3/4.7.7 SNUBBERS

PROPOSED TECHNICAL SPECIFICATION CHANGE - TSP 910003-1
VIRGIL C. SUMMER NUCLEAR STATION
DESCRIPTION AND SAFETY EVALUATION

SCE&G proposes to modify the Virgil C. Summer Nuclear Station Technical Specifications (TS) to revise TS 4.7.7 and associated Bases 3/4.7.7 in accordance with GL 90-09; additionally, the REJECT line in figure 4.7-1 and all references to this line are deleted from the text. The proposed amendment changes the snubber visual inspection schedule of surveillance requirement 4.7.7 to the alternate visual inspection schedule specified by GL 90-09, and changes the associated Bases 3/4.7.7.

FIGURE 4.7-1 SAMPLING PLAN FOR SUNBBER FUNCTIONAL TEST

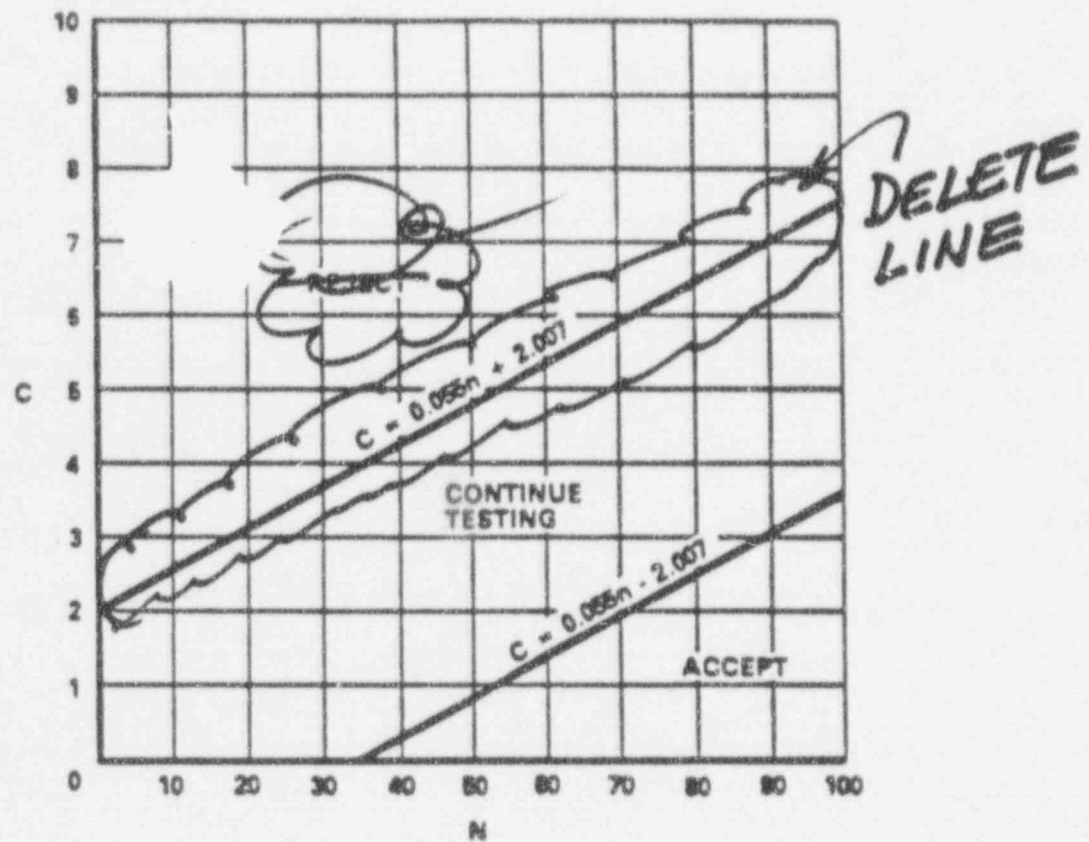
The Reject line, developed using Wald's Sequential Probability Ratio Plan, assumes that the sample is totally homogeneous, and that the failure in the total population is in the same ratio as the failures observed in a given sample. This is not correct when functionally testing snubbers in nuclear power stations. Snubbers can not be considered a homogeneous population, since the sampling for functional testing includes various configurations, different environmental conditions, different sizes, capacities and types of snubbers, and the sample is weighted to include more snubbers from severe service areas.

Deletion of the Reject line in Figure 4.7-1 does not contribute to any reduction in the margin of safety.

the "Accept" region testing of that type of snubber may be terminated. When the point plotted lies in the "Continue Testing" region, additional snubbers of that type shall be tested until the point falls in the "Accept" region ~~on the "Reject" region~~, or all the snubbers of that type have been tested.
